**SUBJECT: COMANCHE PEAK NUCLEAR POWER PLANT, UNITS 3 AND 4
DOCKET NUMBERS 52-034 AND 52-035
RESPONSES TO REQUESTS FOR ADDITIONAL INFORMATION NO. 2828 AND 3698**

Response to Request for Additional Information No. 2828 (CP RAI #124)

Response to Request for Additional Information No. 3698 (CP RAI #109)

Figure 9.02.01-1

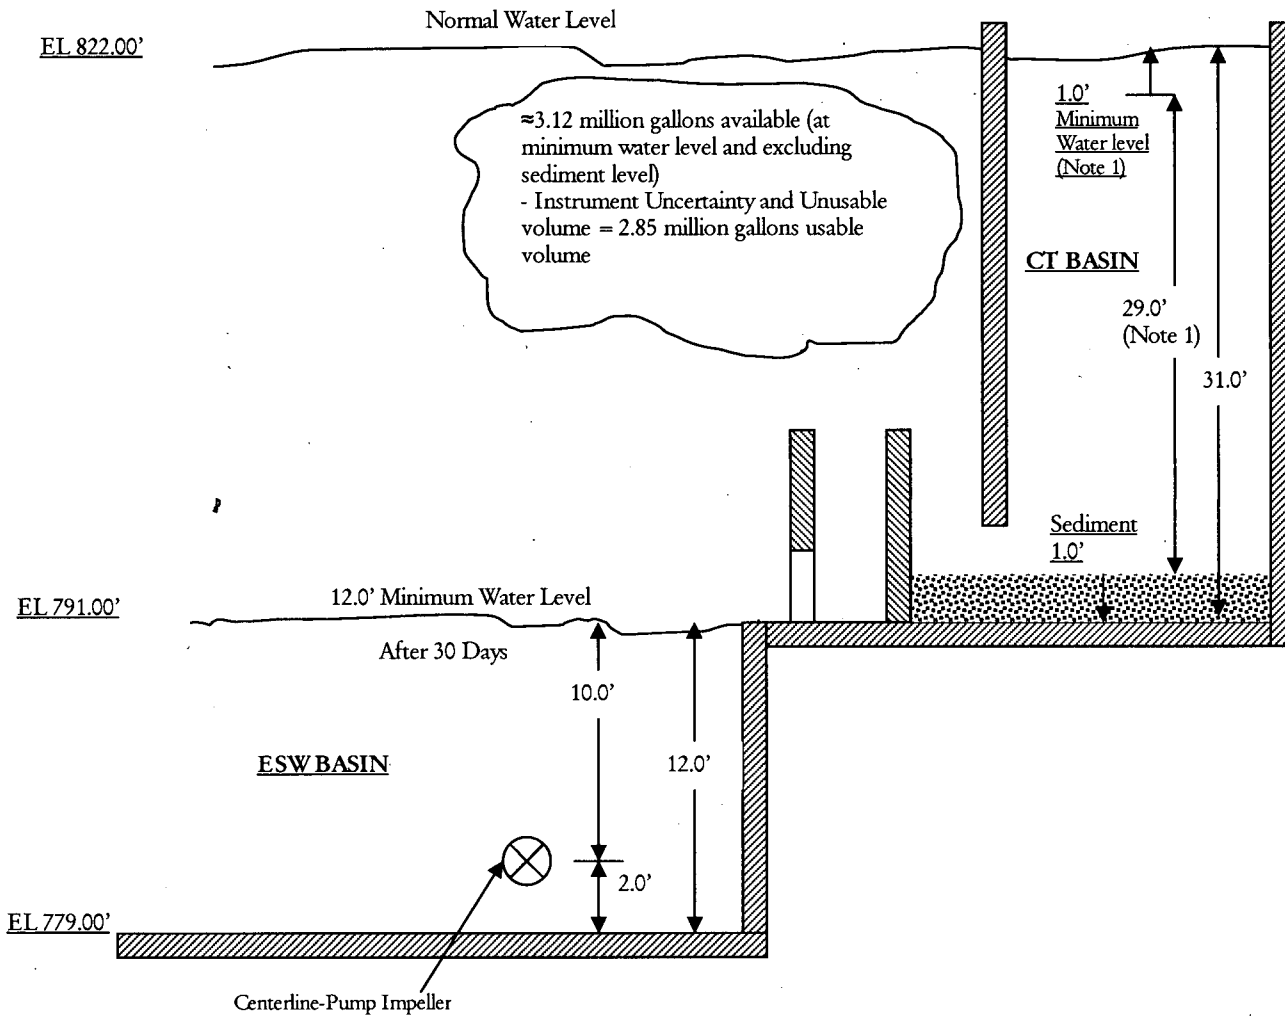
- Discuss pump vortex formation as part of the NPSH evaluation.
- Provide drawings indicating the elevation of the ESWS pump impellers..
- Include in the FSAR the low water level in the UHS to support adequate NPSH.
- Include in the FSAR the NPSH instrumentation for minimum water level to assure ESWS operability.
- Add the minimum water level to the Technical Specifications (TS), Section 3.7.9, "Ultimate Heat Sink," Surveillance Requirements. The TS currently addresses the total volume of 10.7 million liters (2,850,000 gallons) and approximate level of 12.2 meters (40 feet).

Provide a clarification to the following FSAR sections related to basin level to support NPSH. FSAR Section 9.2.1.2.2.1, "ESWPS" describes the available NPSH with the lowest expected water level (after 30 days of accident mitigation) in the basin to be approximately 12.2 meters (40 feet). However the UHS basin level is described as 8.8 meters (29 feet) deep in FSAR Section 9.2.5.3, "Safety Evaluation".

The attached Figure 9.02.01-1 depicts UHS water levels of interest. As noted in FSAR Section 9.2.5, each cooling tower structure consists of the cooling tower (CT) basin located underneath the tower. The Essential Service Water (ESW) intake basin, located underneath the ESW pump house, is adjacent to the CT basin. Both basins are interconnected and maintain the same water level. The CT basin floor elevation is 791 ft. The ESW intake basin floor elevation is 779 ft. The ESWS pump (located in the intake basin) impeller (eye) is located approximately at elevation 781 ft. A vaned basket is installed at the suction of the vertical ESW pump. FSAR Figure 3.8-209 provides a typical section view of the UHS basin including the ESWS pump elevation.

A normal water level of approximately 31 feet above the CT basin floor (822 ft elevation) is maintained during plant operation. This provides a water level of 43 feet in the pump intake basin. Following a design basis accident, water level in the pump intake basin after 30 days without makeup will be approximately 12 feet. The ESW pump is located approximately 10 feet from the basin wall. The UHS transfer pump and the ESW pump from the same basin do not operate simultaneously. Thus the pump submergence, location, and operating restrictions preclude any vortex formation.

As noted in FSAR Subsection 9.2.1, the ESW pump available NPSH at the lowest water level in the basin after 30 days of accident mitigation is approximately 40 feet. The procurement of ESW pumps will assure that the pump required NPSH has adequate NPSH margin at these conditions and the pump operability is not affected. Available NPSH is approximately 71 feet during normal plant operation.

As noted above, following a design basis accident, water level in the pump intake basin after 30 days without makeup will be approximately 12 feet.

The 29-foot water depth in the CT basin described in FSAR Subsection 9.2.5.3 is used for calculating usable water volume allowing for sedimentation and measurement uncertainties. Calculated NPSHA is based on having TS minimum water volume available (from three basins) at the initiation of the accident. FSAR Subsection 9.2.5.3 has been revised to clarify that the minimum volume in the CT basin maintains adequate ESWS pump NPSH under design basis conditions.

Figure 9.02.01-2, Excerpt from FSAR Figure 9.2.1-1R

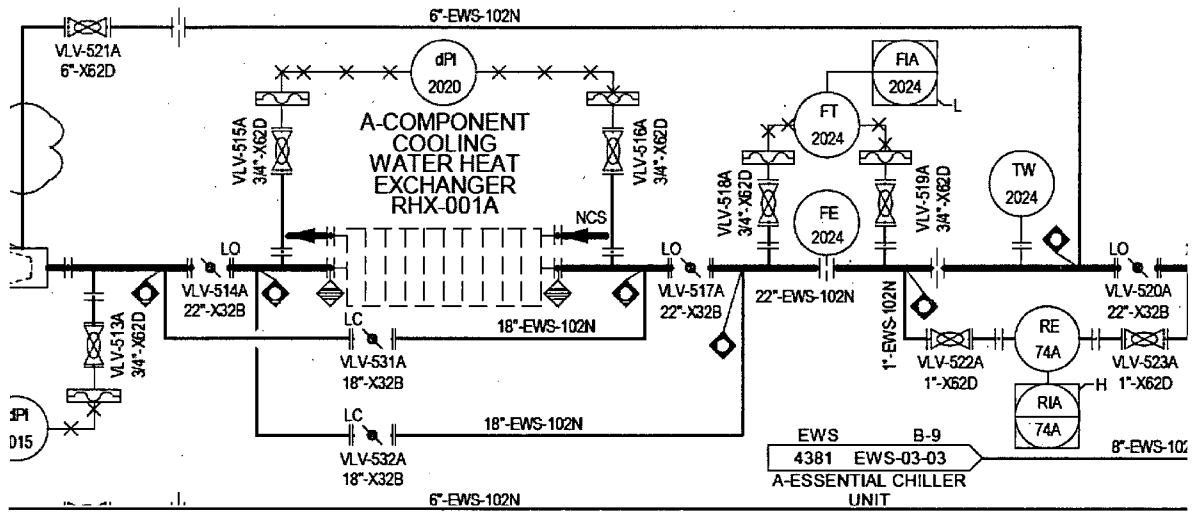
B. The concept of maintaining locked open valves (which are also shown on FSAR Figure 9.2.1-1R, "Essential Service Water System Piping and Instrumentation Diagram") adequately addresses the possibility of over pressurization. However, when these valves are closed for heat exchanger backflush, over pressurization was not adequately addressed by the applicant. Provide a discussion in the FSAR for the over pressurization protection when the locked open valves are closed for heat exchanger flushing.

Back flush operation for a typical train (A) is as follows (refer to the attached Figure 9.02.01-2). Heat exchanger (HX) inlet and outlet isolation valves VLV-514A and VLV-517A are closed and bypass valves VLV-531A and VLV-532A are opened. Water from the inlet of the HX inlet isolation valve VLV-514A flows through the bypass valve VLV-531A and in the HX from the discharge side. The water flows out of the HX from the inlet side to the bypass valve VLV-532A and then to the outlet side of the valve VLV-517A. Thus, the HX is not isolated during back flushing operation; cooling operation is continued and there will not be any overpressurization.

For the thermal overpressure protection of the component cooling water heat exchanger ESW side, the valves located at the component cooling water heat exchanger ESW side inlet and outlet lines are administratively locked open valves. These locked open valves assure protection from the thermal overpressurization due to the erroneous valve operation coincident with the heat input from the component cooling water (CCW) side to ESW side. During backflush operation of the heat exchanger, essential service water flows from the discharge side of the heat exchanger and then exits from the inlet side to the discharge header. Cooling operation is continued and there is no overpressurization.

Figure 9.02.01-3, Typical ESWS – FSS Interface

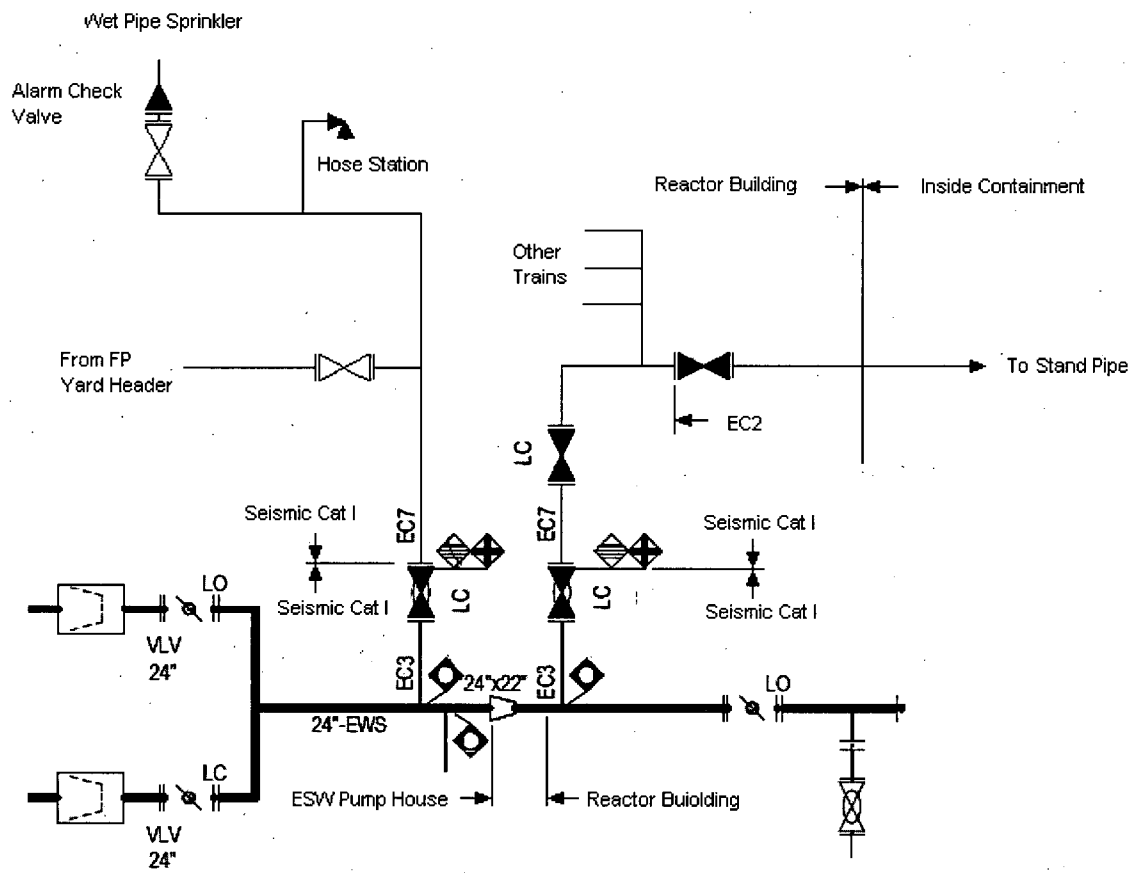
- FSAR Figure 9.2.1-1R, "Essential Service Water System Piping and Instrumentation Diagram," does not graphically show that these normally locked closed (LC) valves are connected to FSS hose stations. Revise FSAR to correctly show a hose or flange connection downstream of the LC valves.

As noted in FSAR Figure 9.2.1-1R, normally locked closed valves are the boundary between the ESWS and the FSS. Attached Figure 9.02.01-3 shows an example of the interface between the ESWS and FSS. Piping downstream of the locked closed, equipment class (EC) 3 ESWS valves, is part of the FSS (EC7 as shown in Figure 9.02.01-3). FSAR Figure 9.5.1-201 will be revised to show the FSS interface with ESWS.
